APPLICATION FOR SOIL INVESTIGATION

APPENDIX H
SITE EVALUATION

(Ground Absorption Sewage Disposal)

OWNER: Don L. Ross
ADDRESS: 8057 Regent Park
COUNTY: Charlotte
LOCATION OF SITE: Rozzell's Ferry Rd

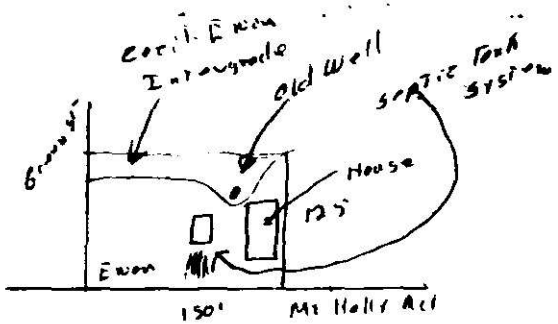
Recommendations/Comments: Most of lot has some Assorted Fill to approximately 12-18" over lot. Also- An old septic Tank system and a bored well are on the lot. Possibility Exists that there is another system behind the old house
